August 4, 1997

RE: Addendum to RBCA Evaluation
Former New Century Beverage Company
1150 Park Avenue, Emeryville, CA
WA Job # 14-0307-98

RE: Former New Century Beverage Company
1150 Park Avenue, Emeryville, California 94608 (STID# 1777)

Benzene Concentrations with Time for MW-5 and MW-13

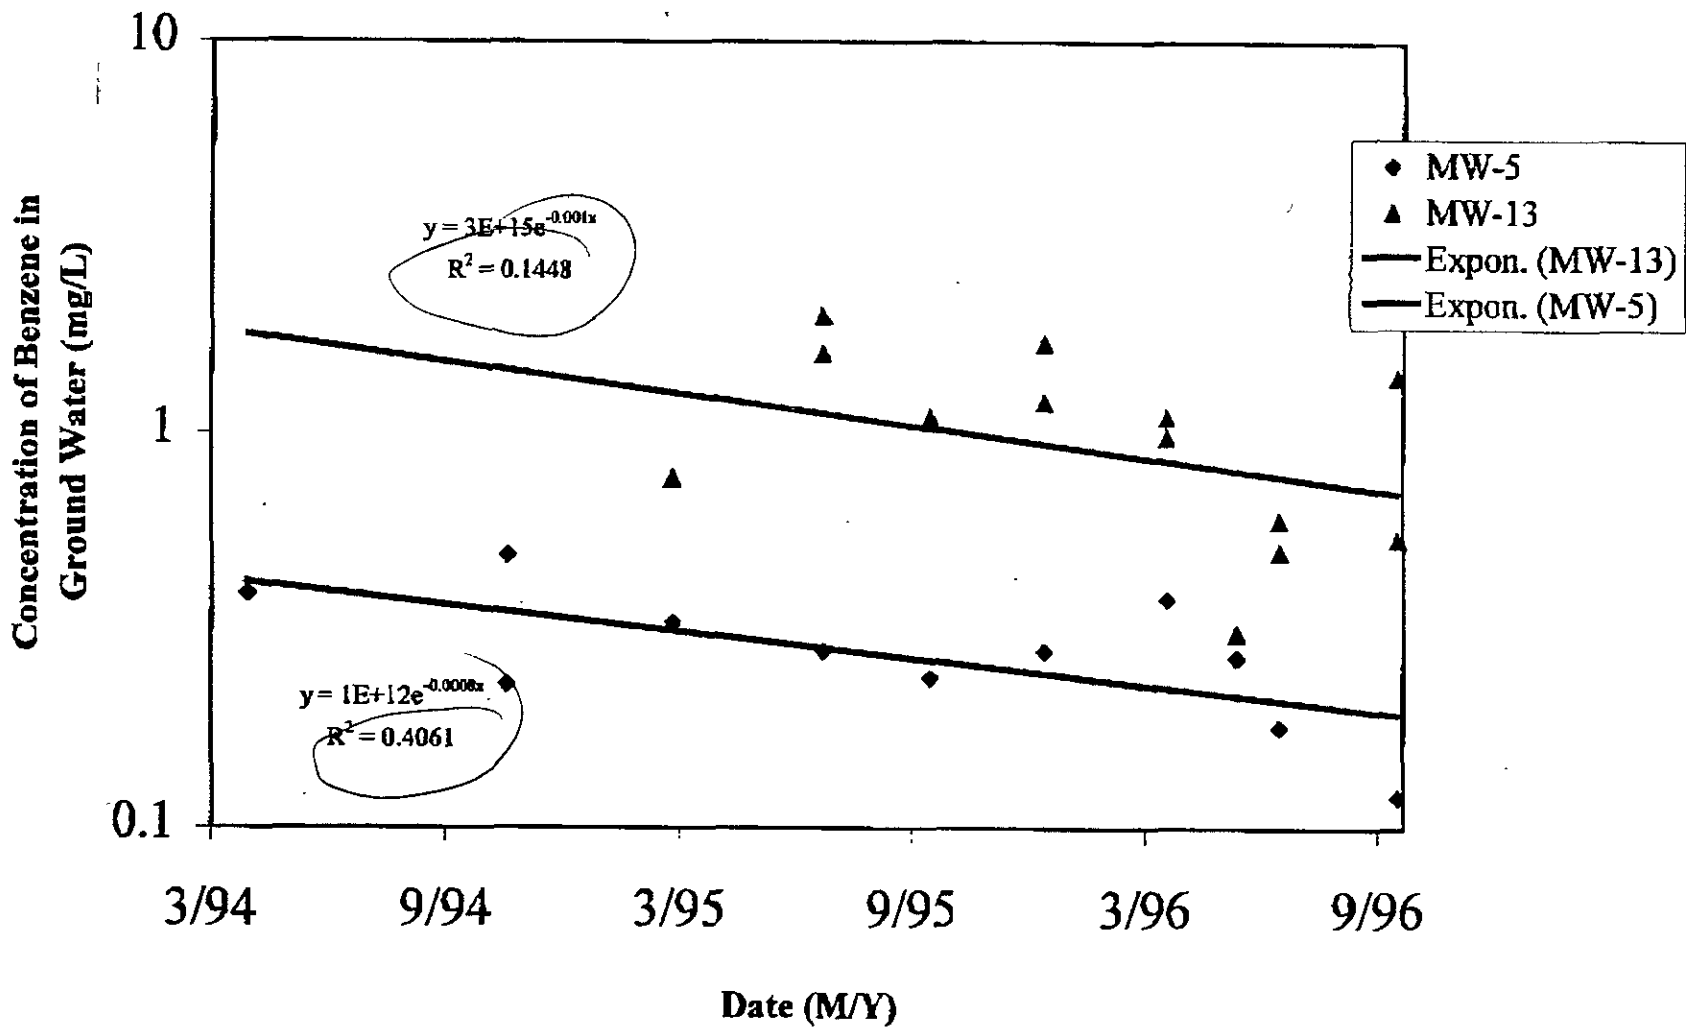
Per our conversation this afternoon, I have attached a revision to Figure 2, Benzene Concentrations (log scale) for MW-5 and MW-13, NCB 1150 Park Avenue Emeryville from our August 4, 1997 submittal to ACHCSA. The revision includes the R^2 values for the trend lines for benzene in these two wells.

In that same submittal we omitted trend lines for MW-12 because the concentrations of TPH and benzene in that well, while detectable, have historically been very low, indicating that MW-12 is outside the contaminant plume. Therefore, we felt the data from MW-5 and MW-13 were most illustrative.

Figure 1. Benzene Concentrations with Time for MW-5 and MW-13, New Century Beverage Facility, 1150 Park Avenue, Emeryville, California.

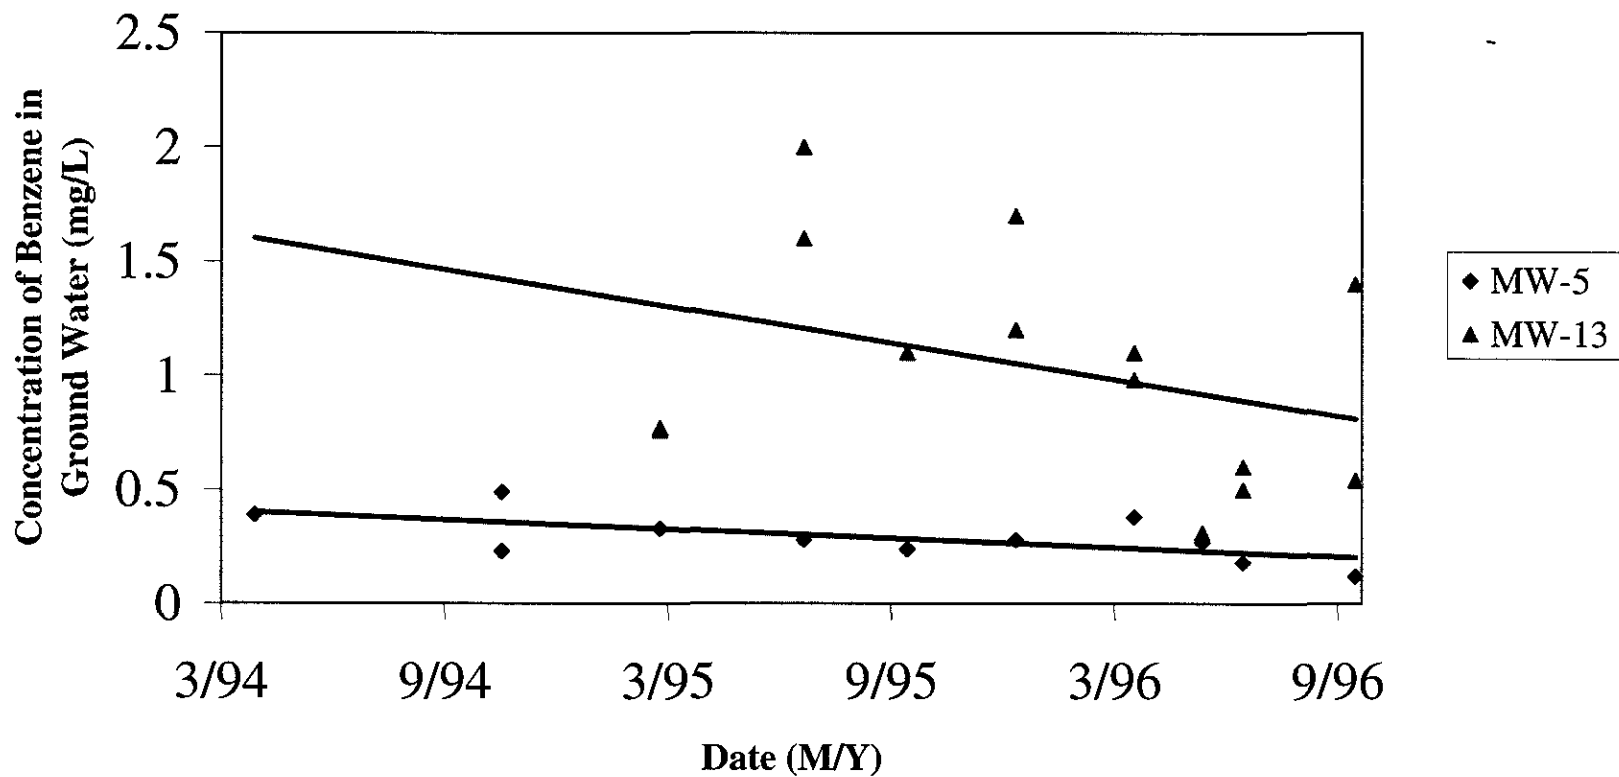
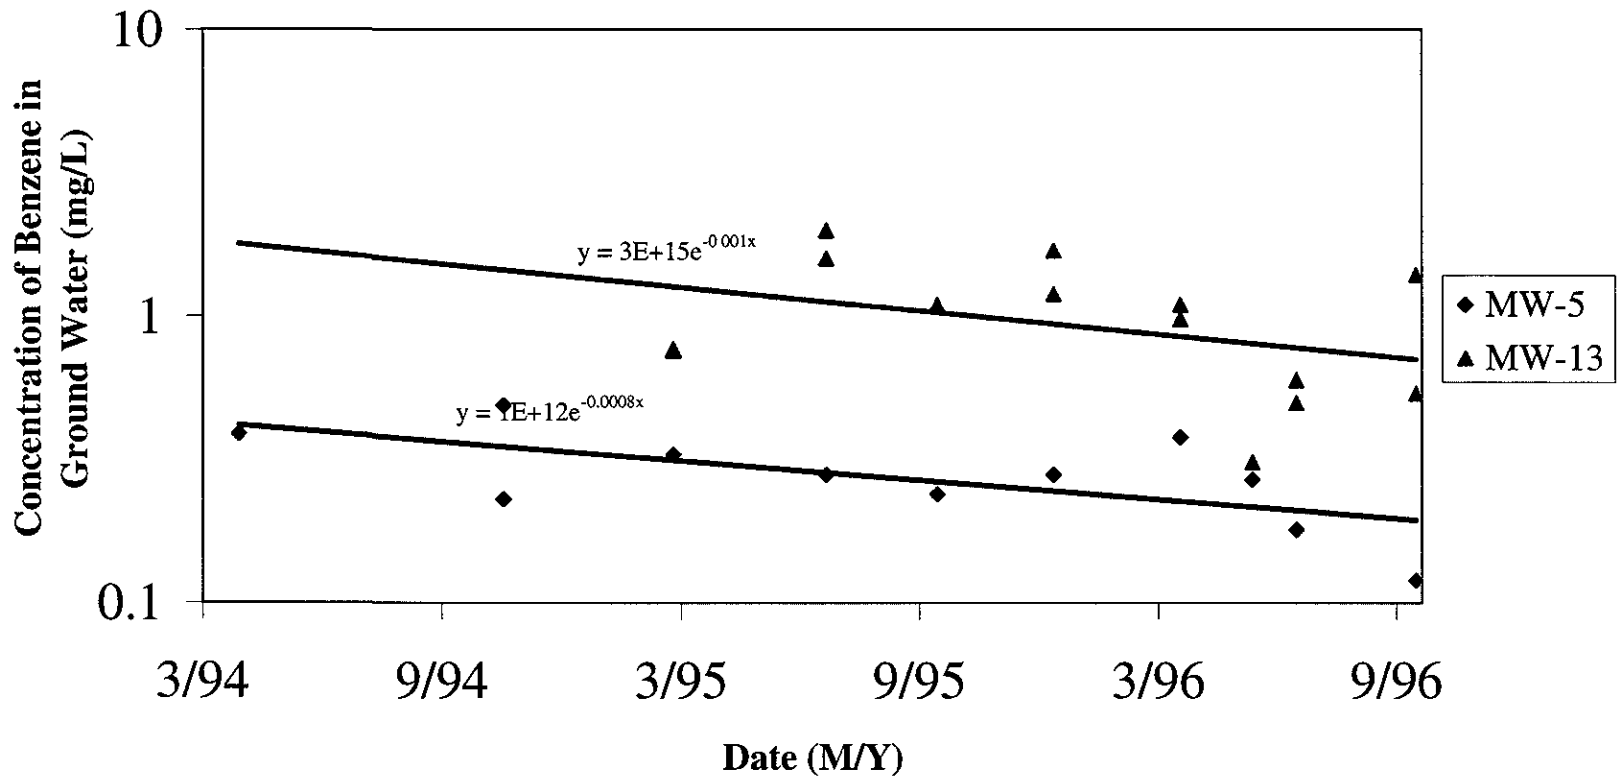
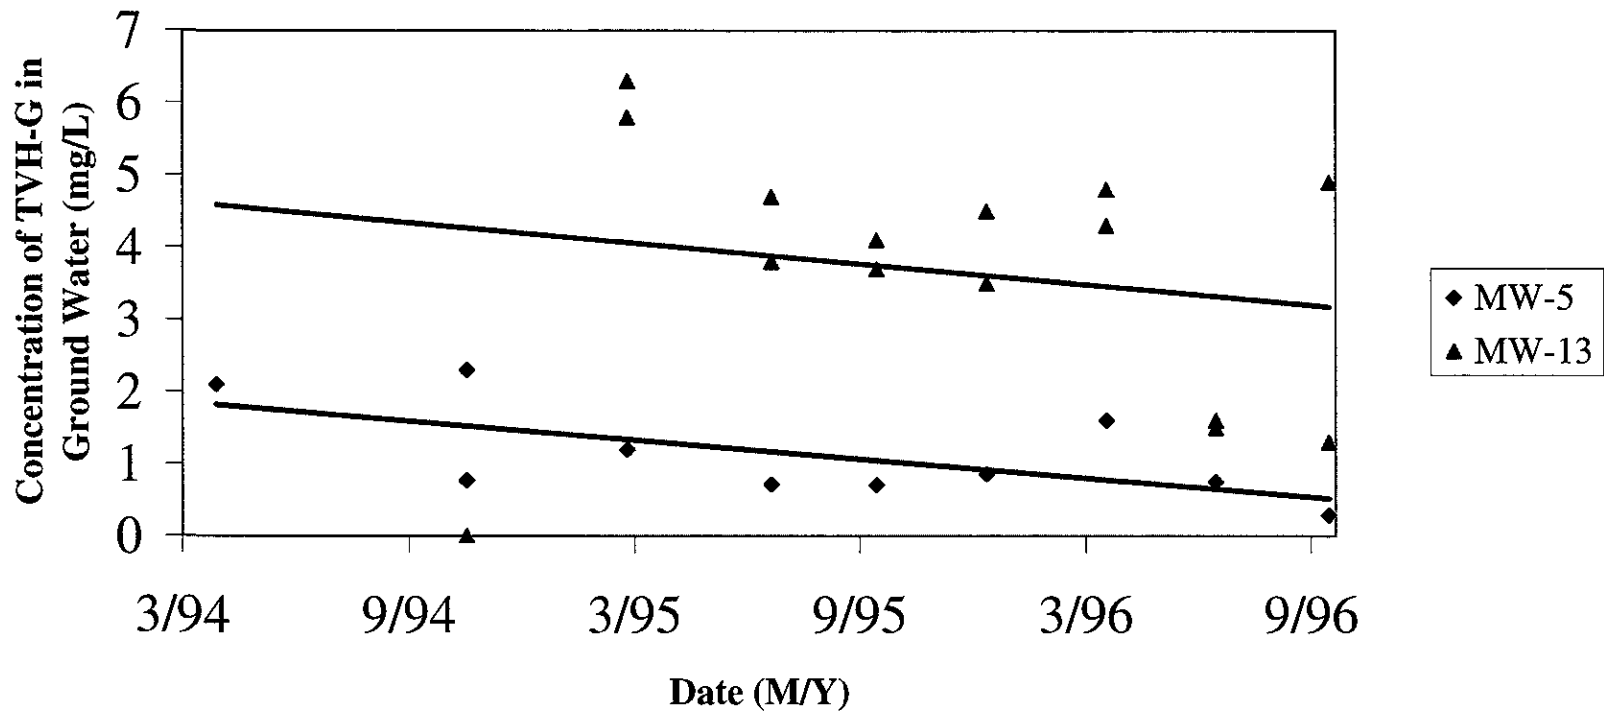
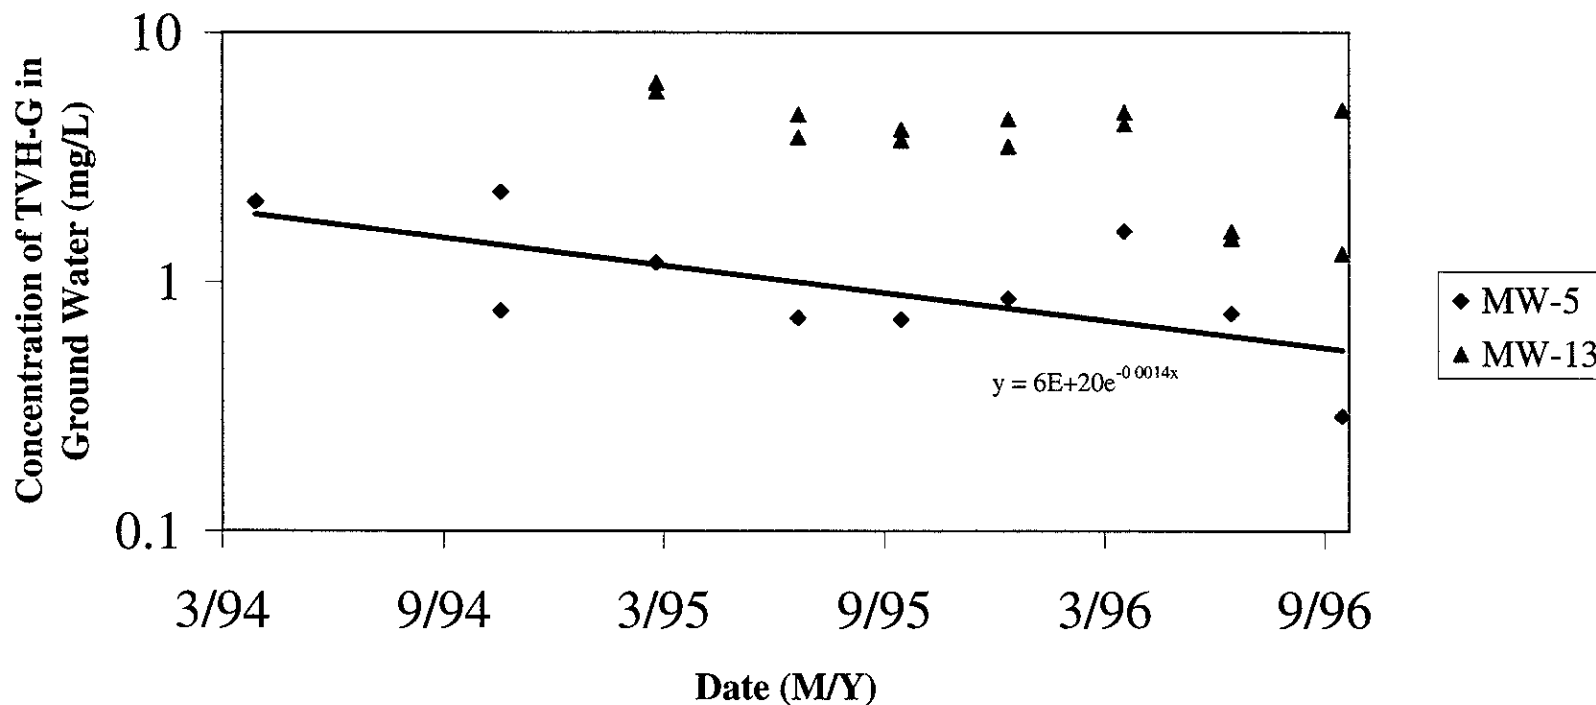
- 1) Groundwater monitoring data collected for three years (3/29/94 to 9/26/96) appears to indicate that the plume is stable. Monitoring well MW-13 located on the Del Monte site and leased by New Century Beverage Co. in November 1992 showed benzene concentration ranging from 310 ppb to 1,700 ppb. However, downgradient wells (MW-8, MW-11 and MW-14) found no detectable concentration of benzene during the entire monitoring period with the exception of one low hit in well MW-14 (2.9 ppb) in 3/96. The plume does not appear to be expanding and may be characterize as a stable plume. Further migration is not likely to occur since aggressive source removal had been conducted at the subject site.

To address the concerns raised by Del Monte regarding continued migration of the plume to their property, a trend analysis should be conducted using the data collected for the three wells detecting benzene (MW-5, MW-12 and MW-13). The trend analysis should include the following: concentration vs. time, concentration vs. distance and log concentration vs. time. In addition, a regression analysis (best fit line) should also be performed.

Item 1, regarding ground water migration. WA agrees that the ground water plume is not expanding and may be characterized as stable. As requested, Attachment B includes a trend analysis examining benzene/TPH concentrations with time and distance for wells MW-5, MW-12, and MW-13.

Benzene and TVH-G concentrations in ground water detected in samples from monitoring wells MW-5 and MW-13 at the former New Century Beverage Company facility have decreased from March 1994 to September 1996 (Figures 1, 2 and 3). From the available data, natural

attenuation half-lives have been determined to vary from 693 to 866 days for benzene and from 408 to 495 days for TVH-G (Table 1).

Figure 5. Benzene Concentrations with Distance, New Century Beverage Facility, 1150 Park Avenue, Emeryville, California.

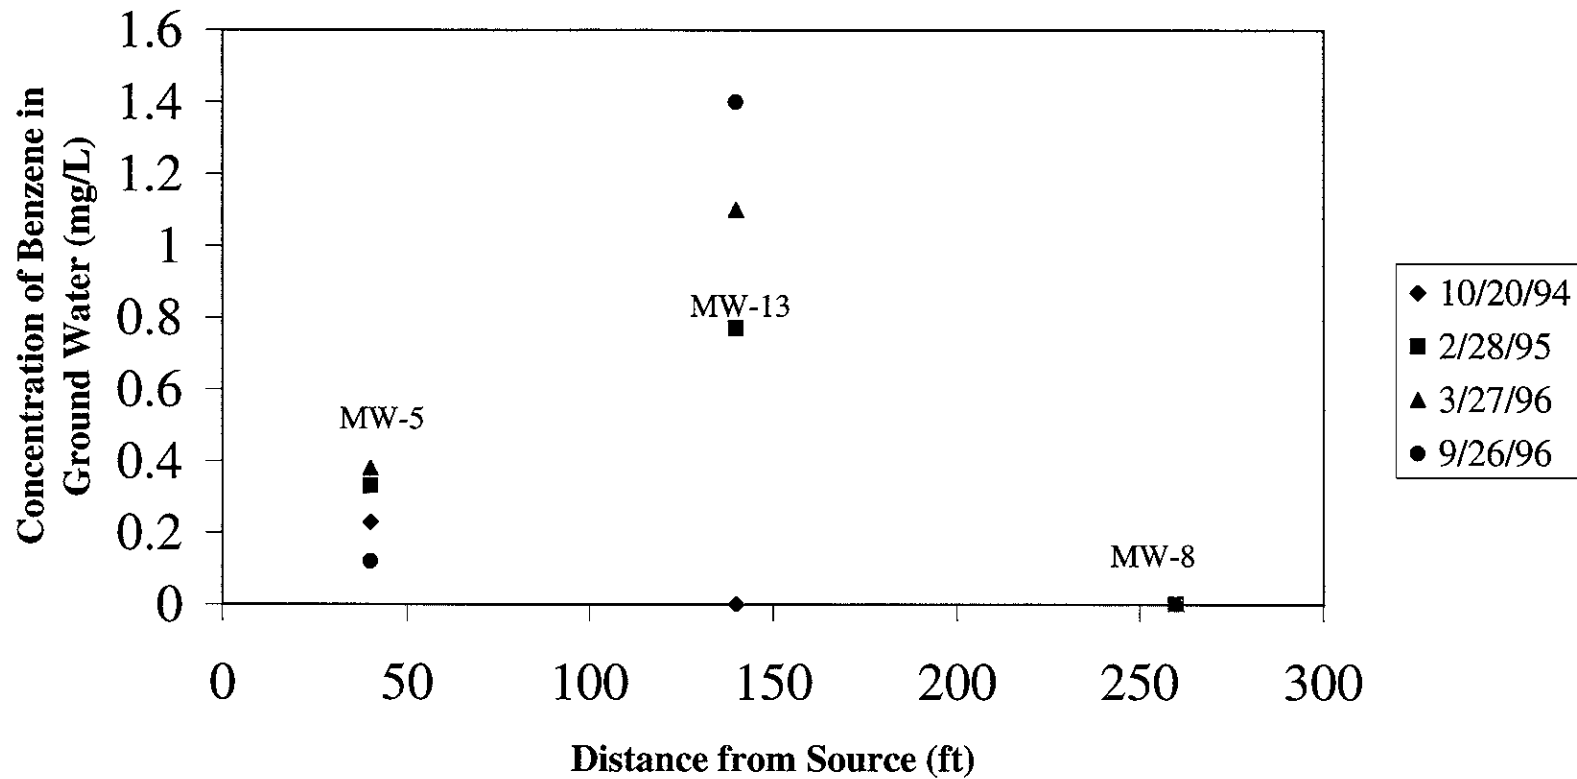
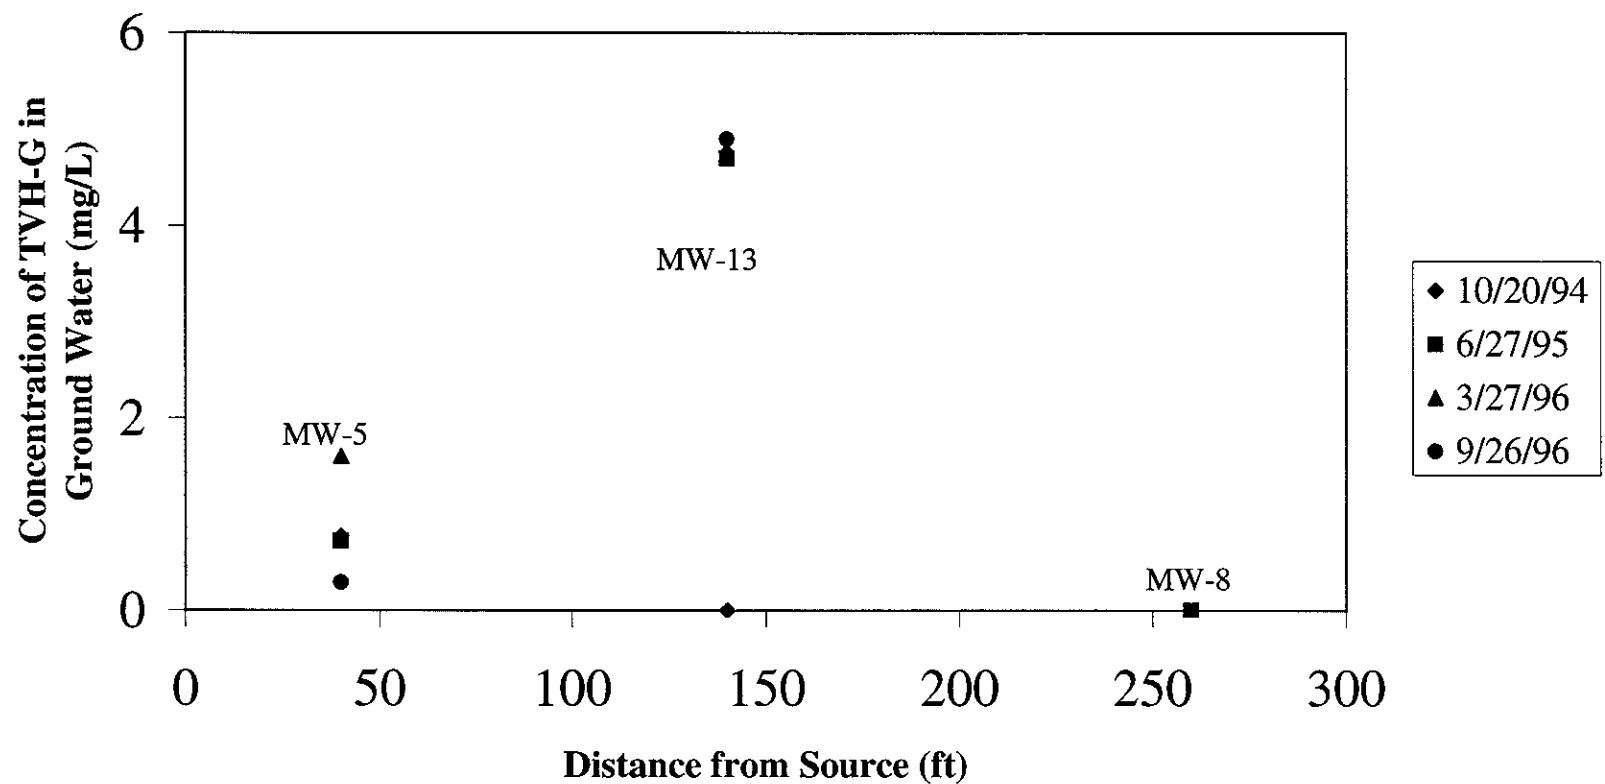
- 8) An evaluation of natural attenuation occurring at the site should be performed. If possible, natural attenuation parameters should be collected at the site.

Item 8, regarding natural attenuation at the site. The data included in Attachment B demonstrate that contaminant concentrations within the ground water plume are decreasing, strongly indicating that natural attenuation is occurring in the ground water beneath the site. The collection of additional field data to support a further evaluation of natural attenuation for the subject site is neither feasible nor warranted at this point in the closure process. We note, however, that the calculation of the Tier 2 SSTL for benzene in ground water for the off-site residential receptor does in fact represent a site-specific value. Appendix E of the Dec 1996 RBCA includes the site-specific SSTL calculations for ground water, generated using a site-specific dilution/attenuation factor (DAF) that reflects site-specific concentration and distance data from wells MW-5, MW-13, and MW-8.

Benzene and TVH-G concentrations in ground water detected in samples from monitoring wells MW-5, MW-13, and MW-8 at the former New Century Beverage Company facility show the typical concentration trend with distance from the source area. Although a slight increase in concentrations is observed from a distance of 40 to 140 ft from the source (MW-5 and MW-13), concentrations drop to below the detection limit at 260 ft from the source (MW-8) (Figures 4 and 5). These results confirm the ideas that the plume does not appear to be expanding and further migration is not likely to occur. These results support the previous recommendation for closure presented in the Risk-Based Corrective Action Evaluation.
